42600 SUMMIT VIEW CT.  
PARKER, COLORADO

LANDSCAPE PLAN  
 SHEET 1 OF 1

# Landscape\_v1-redline.pdf Markup Summary

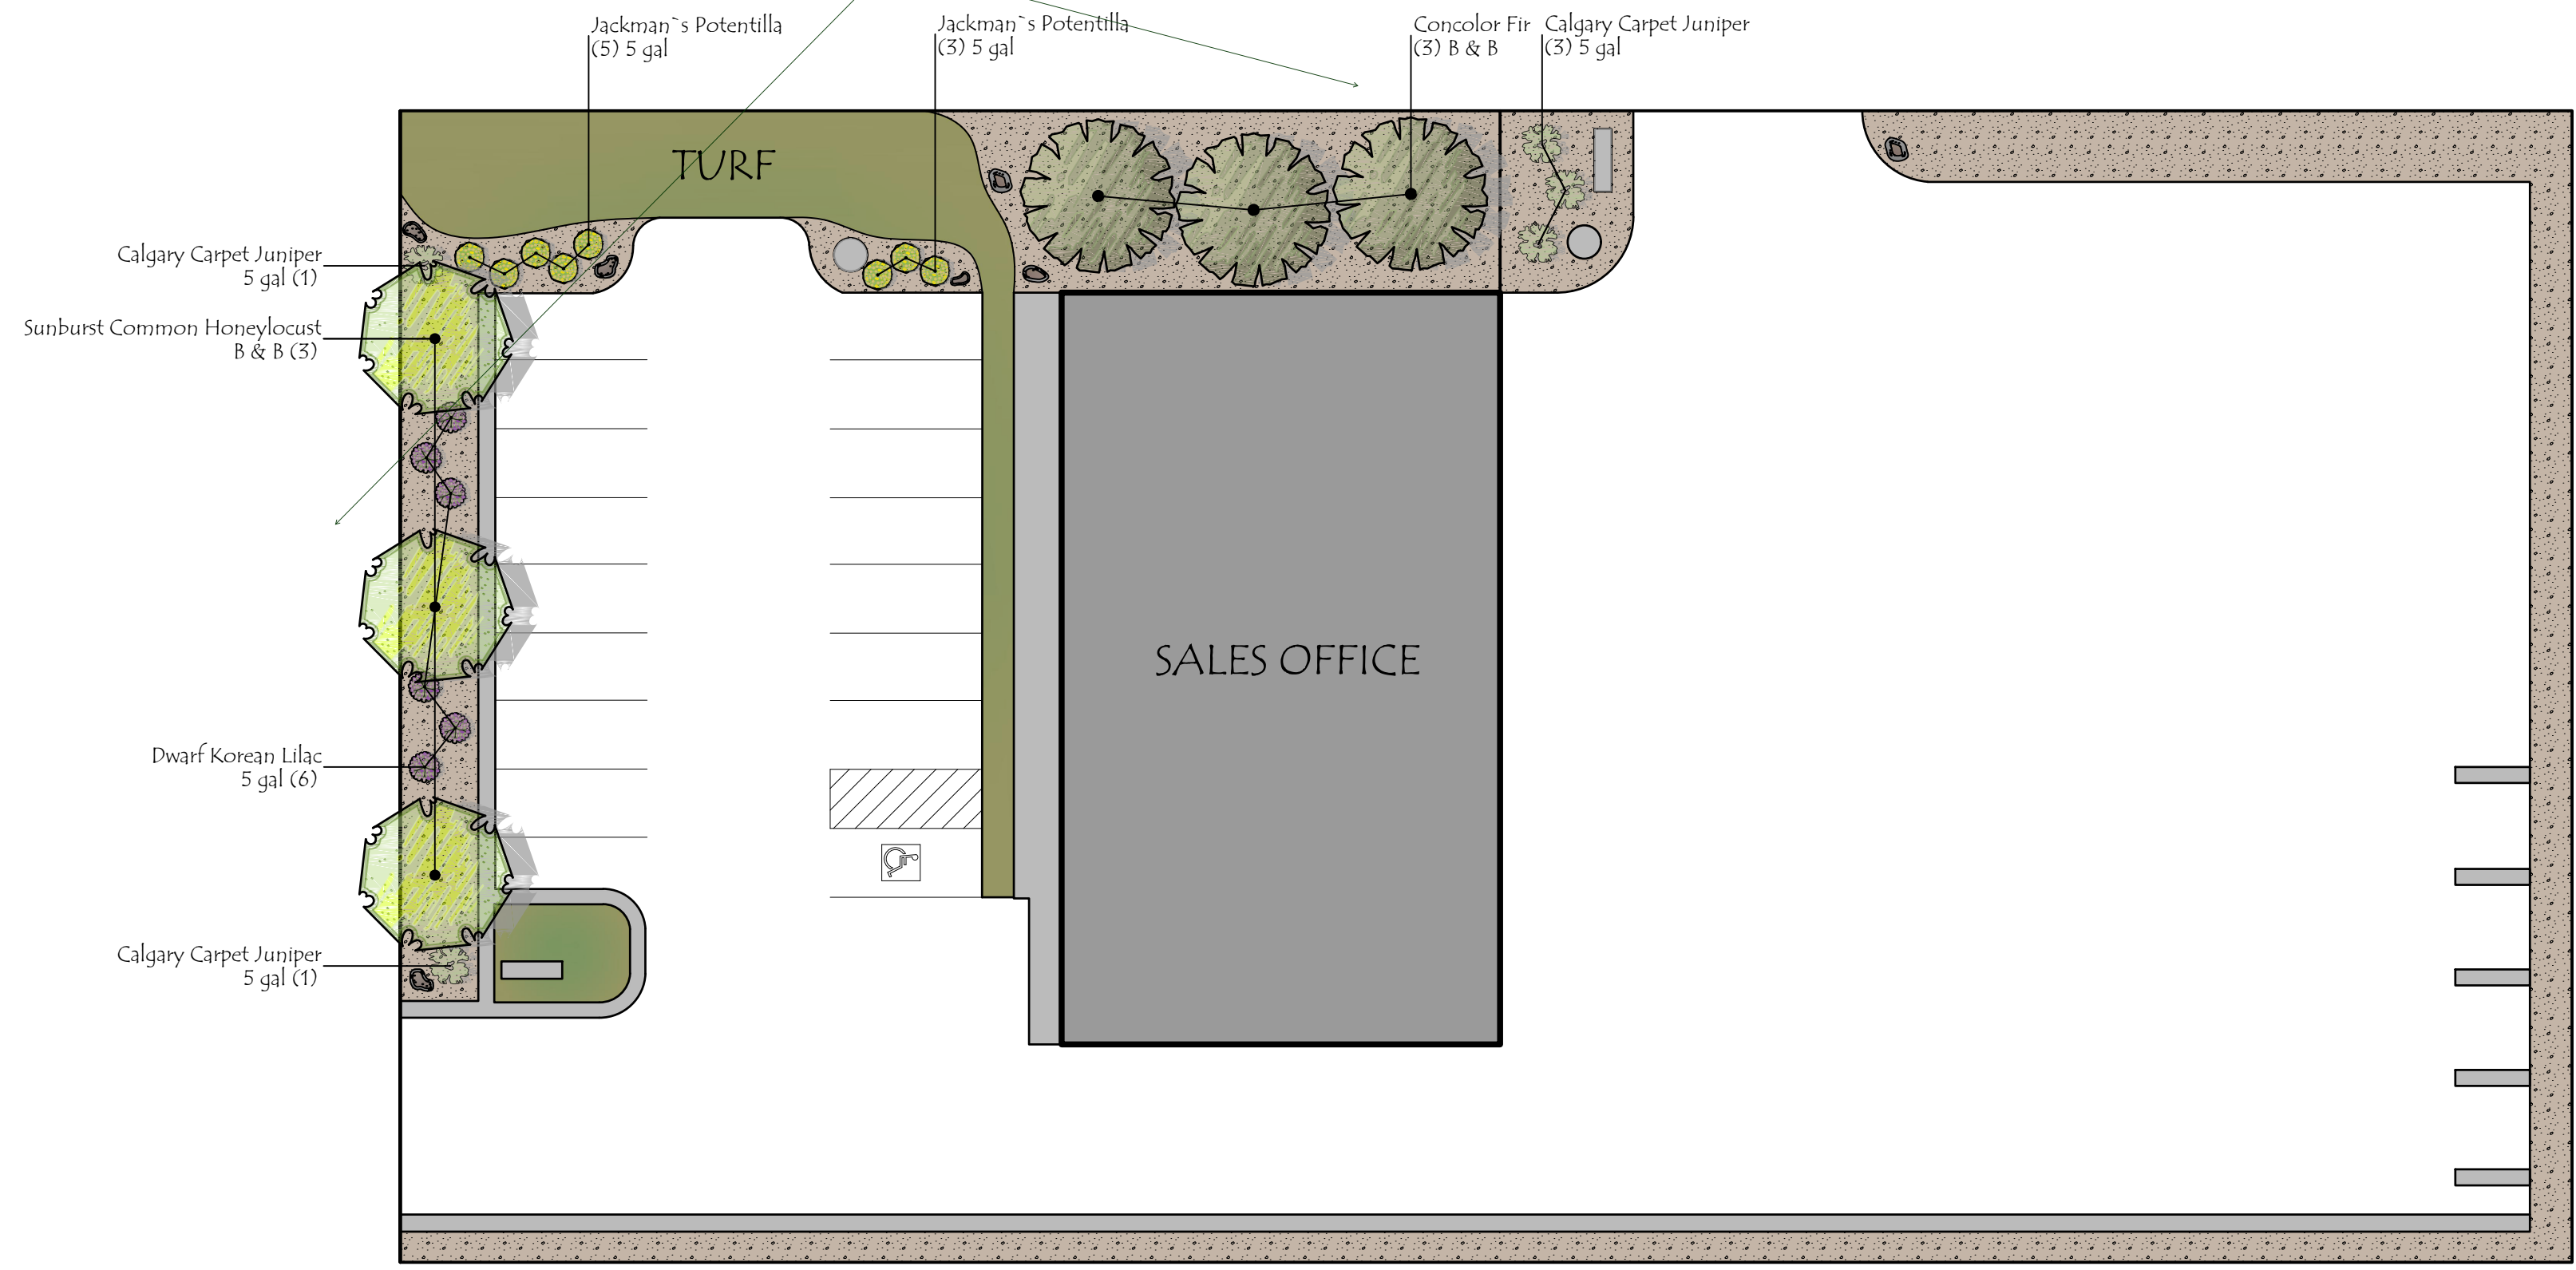
Show how many trees are required as well as provided. Show which type of landscaping they are for, for example:  
 Roadway Landscaping: Required/Provided  
 Internal Landscaping: Required/provided - percentage and trees  
 Etc.

Show distance of frontage.

5 percent of lot area should be internal landscaping, 75% of that should be live ground cover, an alternative landscape plan may be requested, approval of that would be at the Director's discretion.

See chapter 6 of Land Development Code for landscaping requirements.
